Title - Sujet Food Service Bldg Westmorland Inst	
Solicitation No. - N° de l'invitation EC016-141832/A	Amendment No. - N° modif. 001
Client Reference No. - N° de référence du client EC016-141832	Date 2014-01-14
GETS Reference No. - N° de référence de SEAG PW-\$PWB-020-3350	
File No. - N° de dossier PWB-3-36100 (020)	CCC No./N° CCC - FMS No./N° VME
Solicitation Closes - L'invitation prend fin at - à 02:00 PM on - le 2014-01-23	Time Zone Fuseau horaire Atlantic Standard Time AST
F.O.B. - F.A.B. Plant-Usine: <input type="checkbox"/> Destination: <input type="checkbox"/> Other-Autre: <input type="checkbox"/>	
Address Enquiries to: - Adresser toutes questions à: Donovan, Janine PWB	Buyer Id - Id de l'acheteur pwb020
Telephone No. - N° de téléphone (506) 636-5347 ()	FAX No. - N° de FAX (506) 636-4376
Destination - of Goods, Services, and Construction: Destination - des biens, services et construction:

This Tender Amendment No. One (1) is raised to include the following Addendum No. One (1).

Addendum No. 1

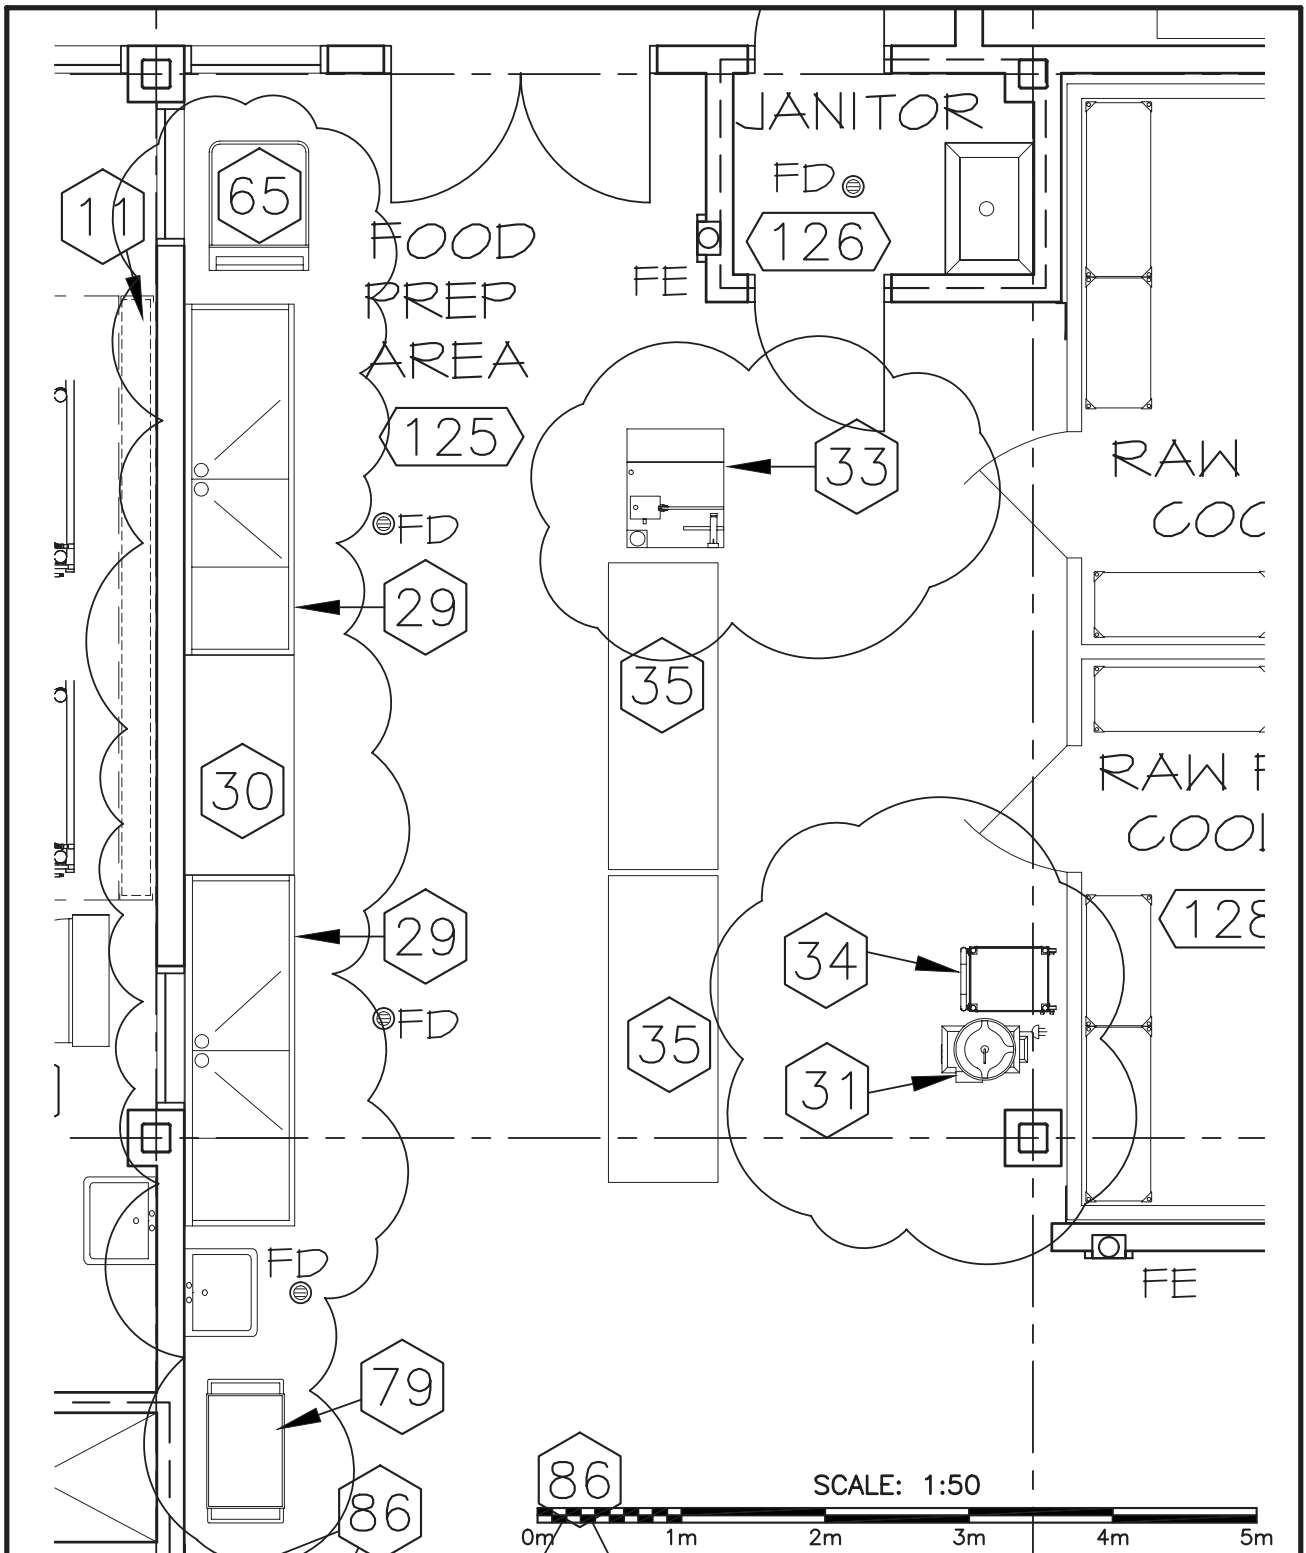
.1 Quantity: revise from 1 to 2. Refer to attached sketch layout FSK-01.

1. **DRAWING FS.2 - GROUND FLOOR EQUIPMENT LAYOUT**

- .1 Change equipment layout in Food Prep Area (125) as indicated on sketch FS SK-01 (attached).
 - .1 Add 1 additional item # 29 as shown.
- .2 Relocate the following items as shown on sketch FS SK-01 (attached).
 - .1 Item #31 Vegetable processor
Services: 10 Amp - 208 v - 1 phase outlet on wall.
Floor drain.
 - .2 Item #33 Vacuum clipper w/nozzle
Services: Verify with Owner.
6 amp - 208 volt - 1 phase electric outlet on wall.
Compressed air inlet.

| .3 | Item #34 | Cart for Vegetable Processor |
| .4 | Item #65 | Garbage container |
| .5 | Item #79 | Stainless steel utility cart |
